# DEVELOPMENT REVIEW BOARD REPORT

CASE NUMBER/ PROJECT NAME	<b>101-DR-2005 SL-12 (Adobe Apartment-to-Condo Conversion)</b>		
LOCATION	3635 N. 68 <sup>th</sup> Street		
REQUEST	Request approval of site plan and elevations to convert an existing 12-unit apartment complex into condominiums, including a remodel/upgrade to the building façade facing N. 68 <sup>th</sup> Street.		
OWNER	AJK Management 480-560-0131	ENGINEER	N/A
ARCHITECT/ DESIGNER	LNB Enterprises 602-757-4994	APPLICANT/ COORDINATOR	Andrew Knutson Monkey Wrench Rehab 602-538-0257
BACKGROUND	<p><b>Zoning.</b> The property is zoned Multi-Family Residential District with Downtown Overlay (R-5/DO). Multi-Family uses are permitted in this district.</p> <p><b>Context.</b> The existing apartment complex is located on 68<sup>th</sup> Street south of 2<sup>nd</sup> Street. Adjacent Uses:</p> <ul style="list-style-type: none"><li>• North: Two-Family Residential zoned (R-2), Downtown Overlay (DO).</li><li>• South: Multi-Family zoned (R-5) Downtown Overlay (DO), Single-Family Residential zoned (R1-7).</li><li>• East: Multi-Family zoned (R-5), Downtown/Residential Hotel Subdistrict (D/RH-2), Downtown Overlay (DO).</li><li>• West: Singl

LANDSCAPE LAYOUT

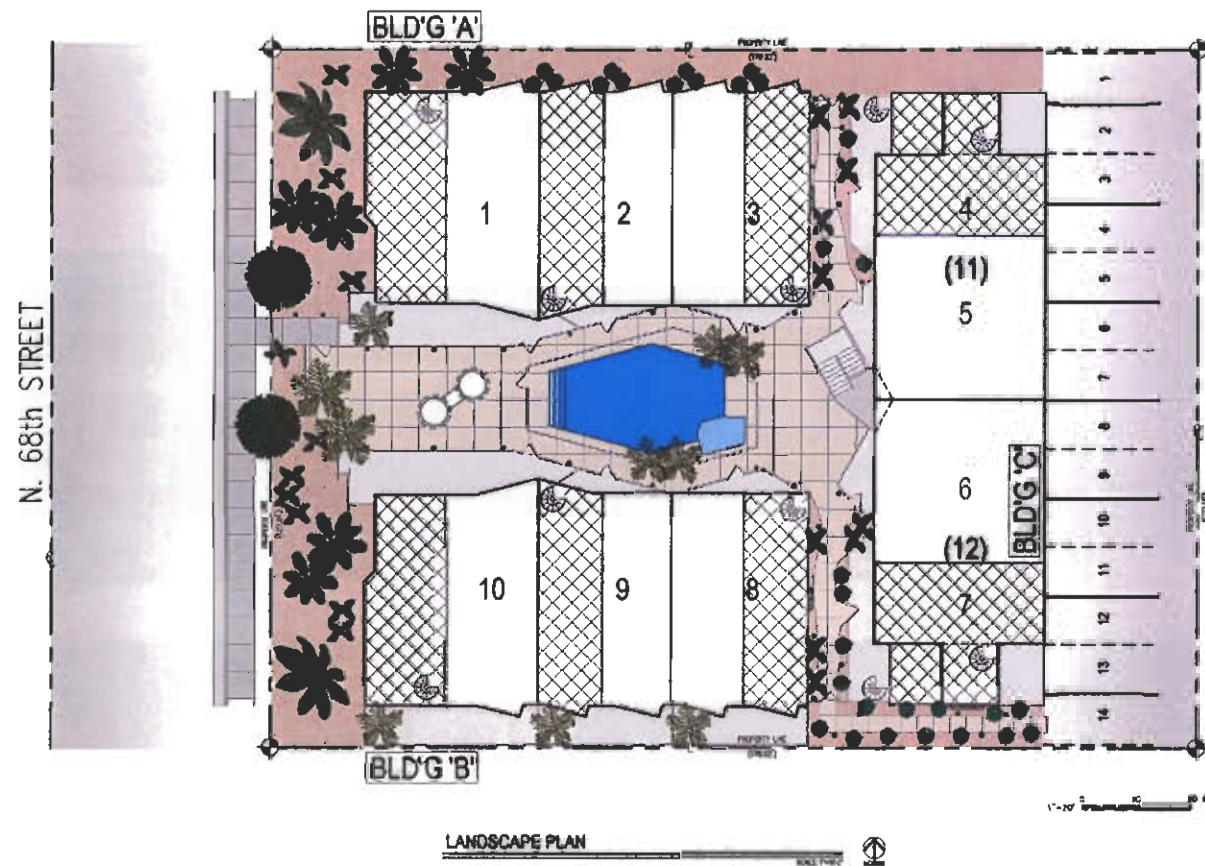
11. *The landscape plan shall be revised to show additional groundcover and/or trees in the open space along 68<sup>th</sup> Street, to the satisfaction of final plans staff.*
